NORTHEAST UTILITIES

Millstone Nuclear Power Station, Unit 3
Transmittal of Response to Request for
Additional Information and Draft
SER Open Items
Structural and Geotechnical Engineering Branch (SGEB)

Question No. Q241.7 (Section 2.5.4.8.3 and SRP Section 2.5.4)

Dynamic Response Analysis of Beach Sand

FIGURE 2.5.4-75

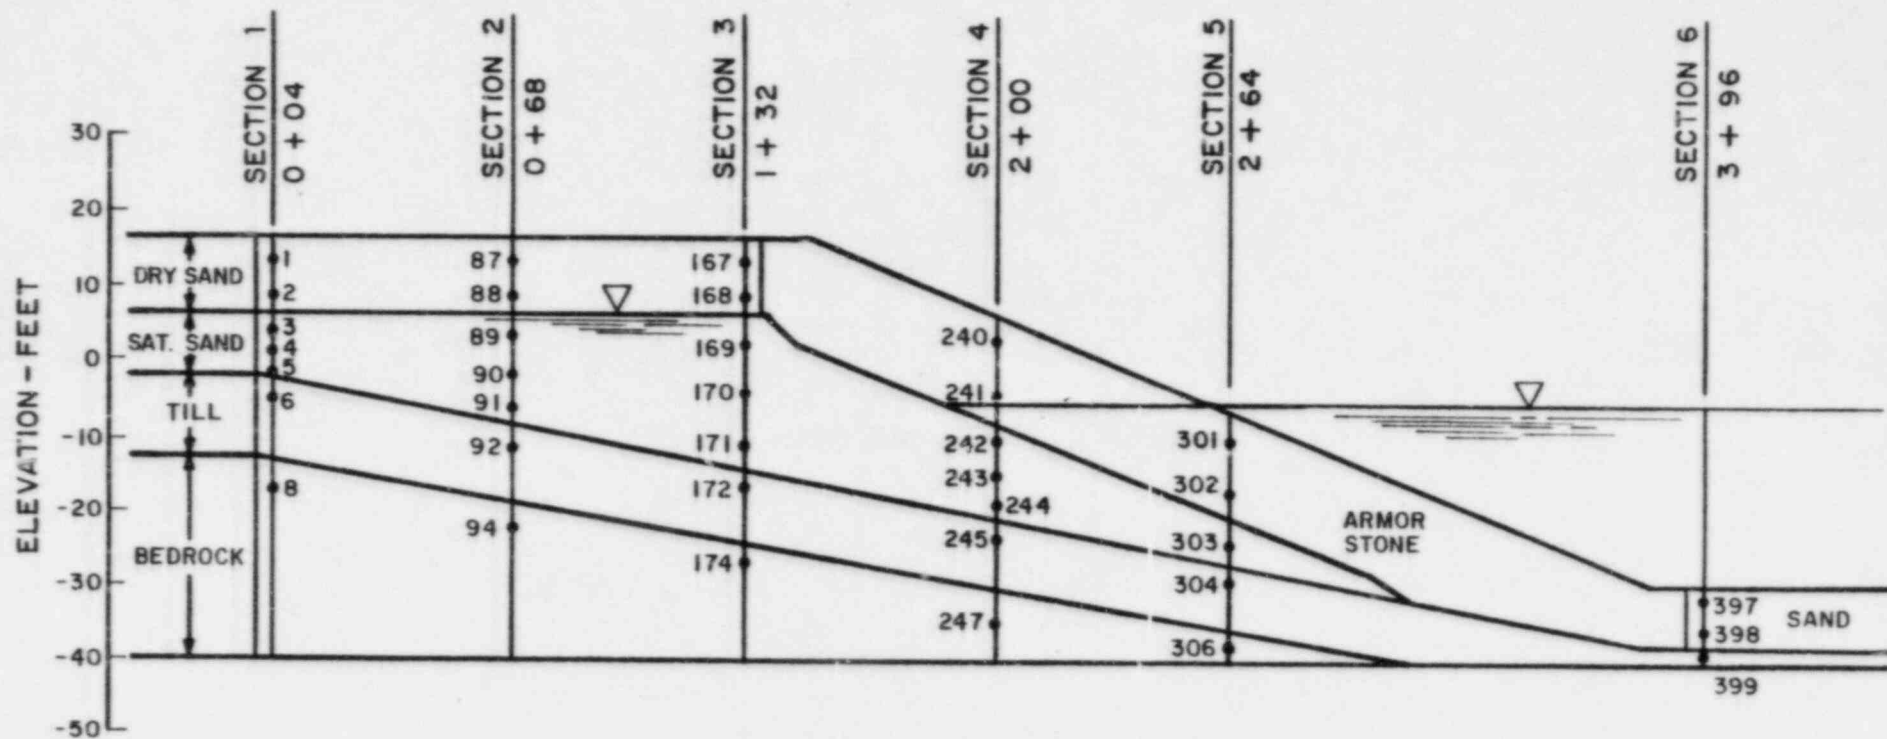
Section 2.5.4.4 of the Draft SER for Millstone Nuclear Power Station, Unit 3 (Reference 1) and Question 241.8 (Reference 2) request that a two-dimensional dynamic analysis be performed to confirm the stability of the beach sand deposits. The attached response (FSAR Section 2.5.4.8.3.3) provides a discussion of the results of this analysis and concludes that liquefaction of the shorefront slopes will not occur and that liquefaction of the intake channel bottom would not affect the integrity of the shorefront slopes adjacent to the circulating and service water pump house or result in a condition that would make the service water system inoperable.

The profile used in the analysis is shown on Figure 2.5.4-75.

Liquefaction potential was calculated at each element for the 6 sections shown on this figure. The results of the PLAXLY analysis and the calculated values of Safety factor against liquefaction are presented on Table 2.5.4-24.

The results of the analysis, presented on Table 2.5.4-24, indicate that the safety factor for elements 1 to 5 are all greater than 1.25. Low safety factors were determined for Section 6, mainly because of the low vertical effective stress near the surface of the intake channel at elevation -29 ft. The effective stress increases to the west of this profile location as the side-slopes of the intake channel rise to meet the natural ocean bottom, making these low safety factors a local phenomenon limited to the intake channel only. The post-earthquake slope stability analysis presented in Section 2.5.5.2.1 was reanalyzed to consider the effect of liquefaction of the sand in the intake channel (Soil 7 on Figure 2.5.5-4) on stability of the shorefront slopes. No change in the safety factor of the critical failure circle was calculated, indicating that the shorefront slopes would not fail in the event that the sand in the intake channel would liquefy.

It can be concluded from this analysis that liquefaction of the shorefront slopes will not occur and that liquefaction of the intake channel bottom would not effect the integrity of the shorefront slopes adjacent to the Circulating and Service Water Pumphouse. The soil underlying the service water pipe encasement adjacent to the pumphouse is not susceptible to liquefaction.
